**PLAN COMMISSION MEETING
IN PERSON AND VIA ZOOM
TUESDAY, APRIL 14, 2026 – 4:00 PM
CITY HALL – SECOND FLOOR**

MINUTES

*b. Review and possible recommendation to the City Council relating to a **Certified Survey Map** for the properties known as Lots 12 and 13 in the Klement Business Park (parcel numbers 226-0514-1742-000 and 226-0514-1742-003) (SPR-2025-18) (Draeger, Director of Neighborhood and Building Services)*

- c. *Review and possible action relating to a Site Plan Review for two Industrial Buildings located on Lots 12 and 13 in the Klement Business Park (parcel numbers 226-0514-1742-000 and 226-0514-1742-003) (SPR-2025-18) (Draeger, Director of Neighborhood and Building Services)*

4 WEST ELEVATION
A300 3/16" = 1'-0"

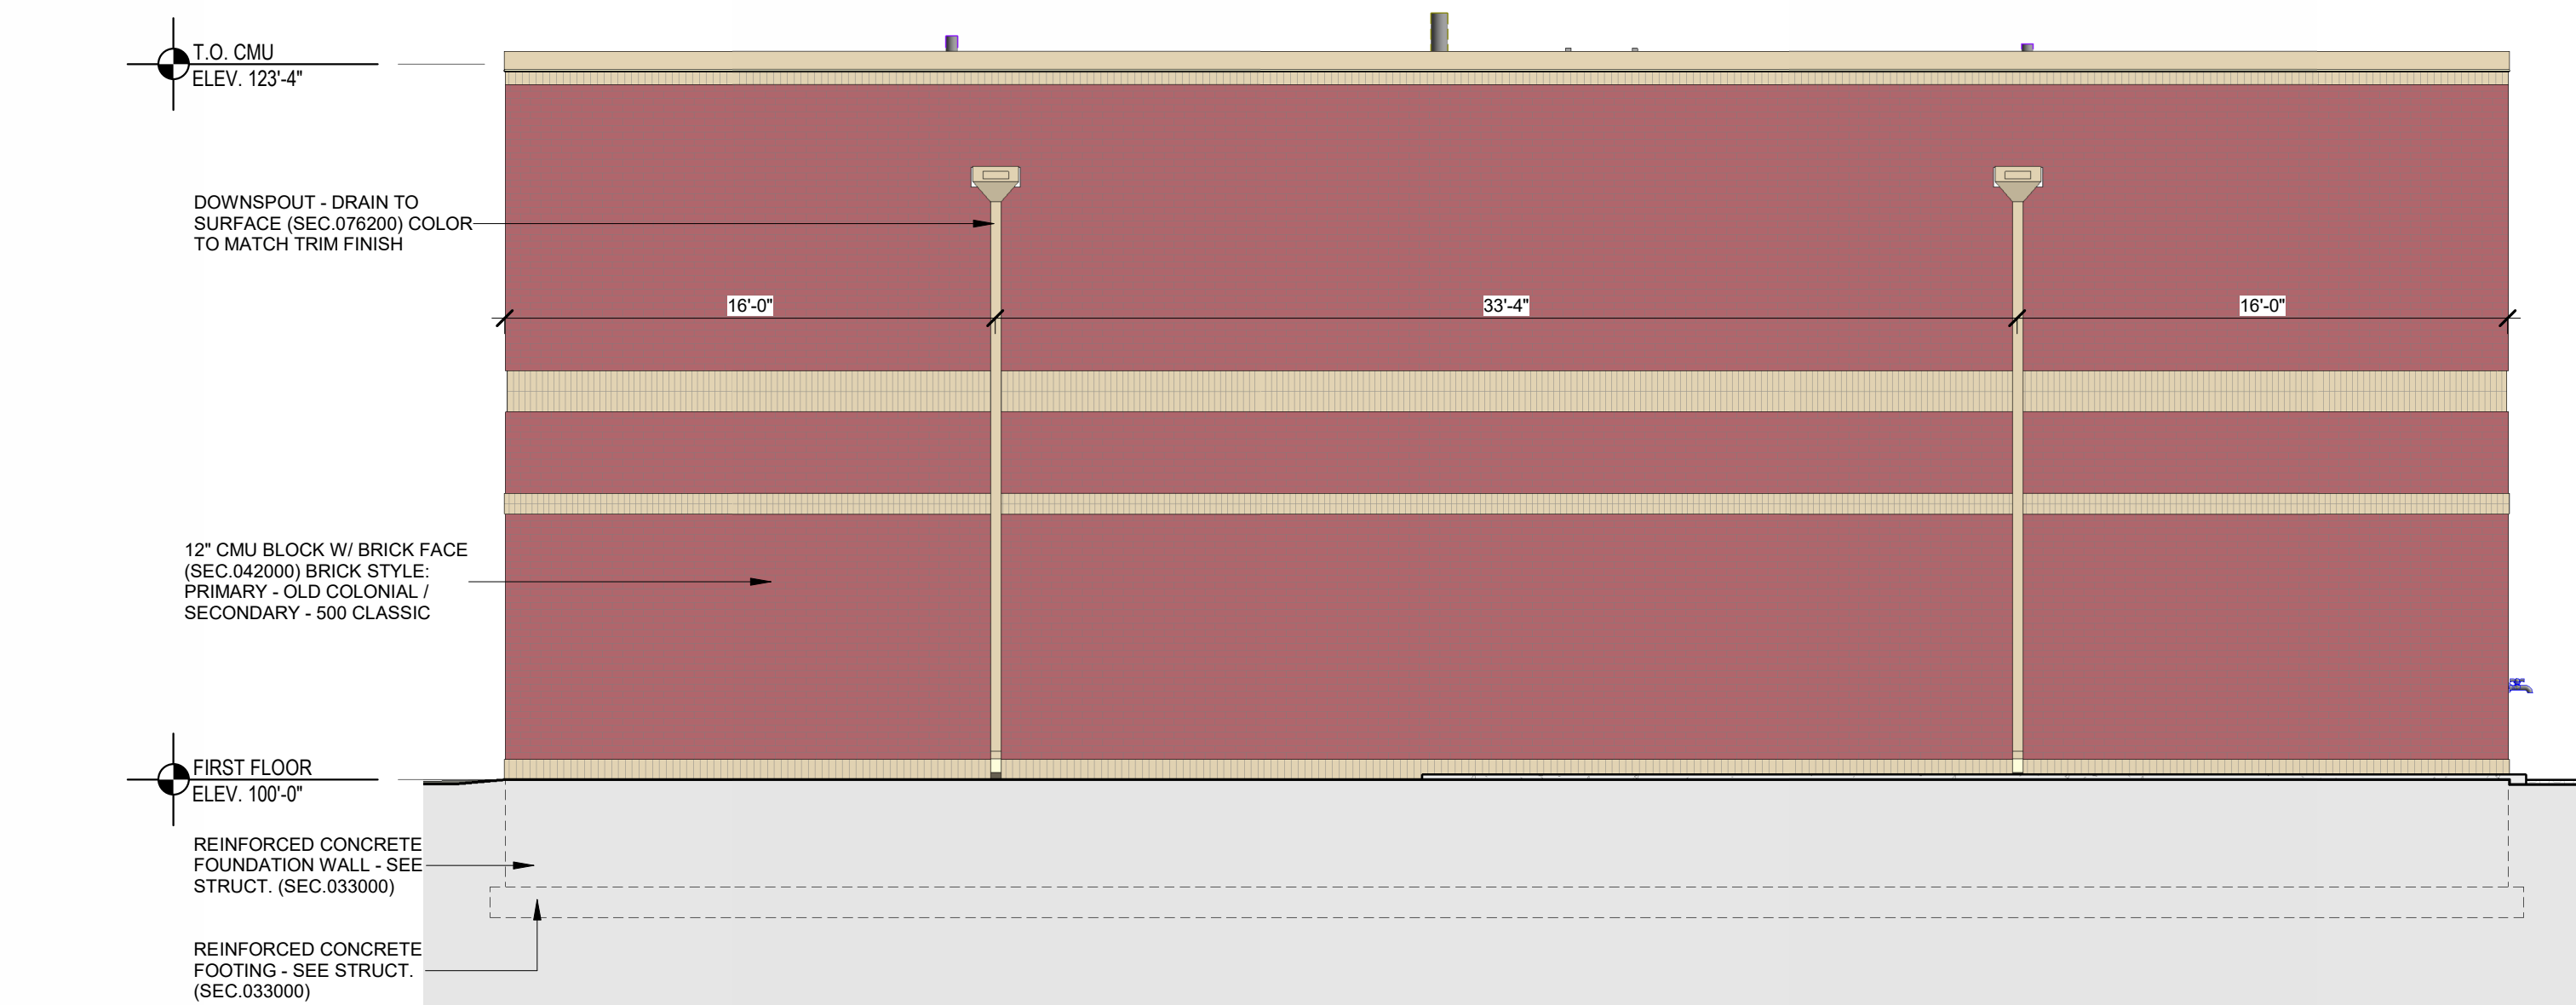
Kessenich questioned the materials or color of the canopies on the exterior of the building. Director Draeger indicated that it was not clear from the plan and would bring it back to the applicant.

Ciccarelli noted that this building will be a flagship building and at the gateway to the business park. He suggested enhancing the side façade to better resemble the front. While mindful of project costs, he felt it was worthwhile to raise this consideration early in the planning process. He also inquired about the roof plans and whether a skylight is planned, noting its potential to improve employee satisfaction. Director Draeger indicated that we do not typically see roof plans unless there would be mechanical or other items needing review. Finally, Ciccarelli proposed keeping the roof plans open to potential future solar development and listed several local businesses utilizing solar.

1. Details relating to the material and color of the canopies
 2. City Council approval CSM
 3. Minor changes to the site plan and facade can be City Staff can be approved administratively, but major changes come back to this body for approval.

CONDOMINIUM PLAT OF
RIDGE VIEW ESTATES TOWNHOMES

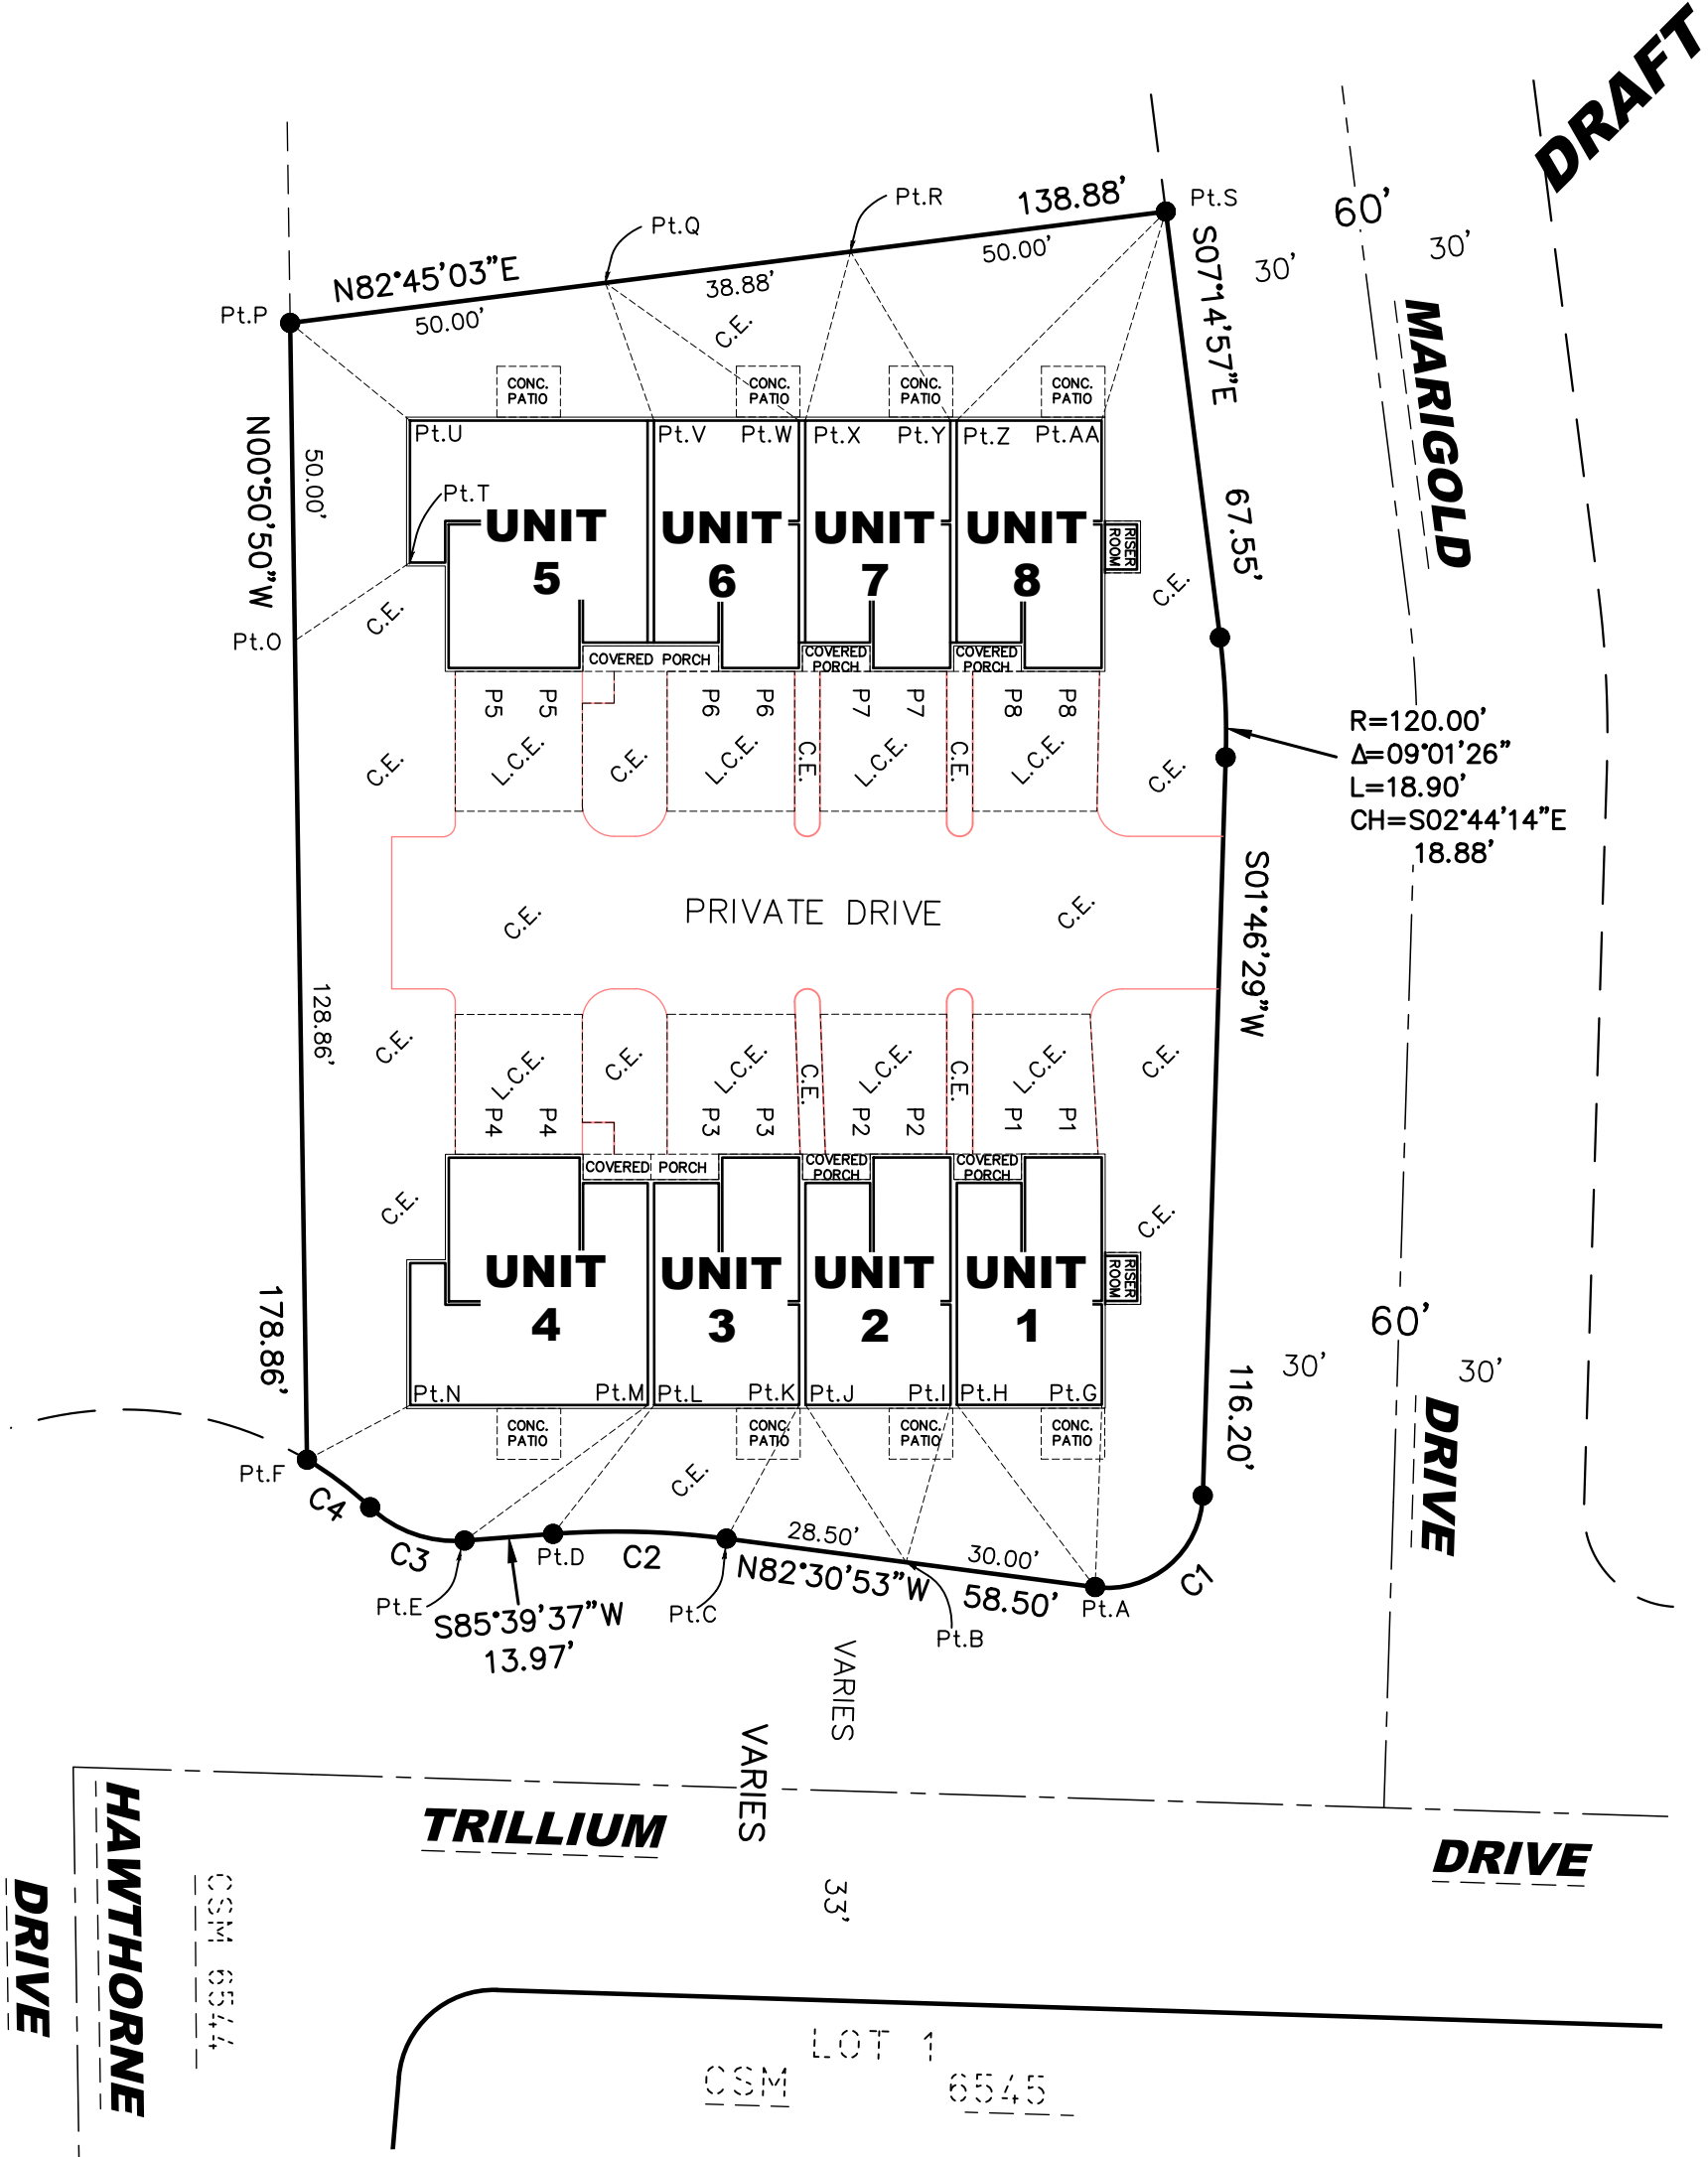
1) In NOTES 6. on Sheet 2, "Limited Common Areas" to be changed to "Limited Common Elements"
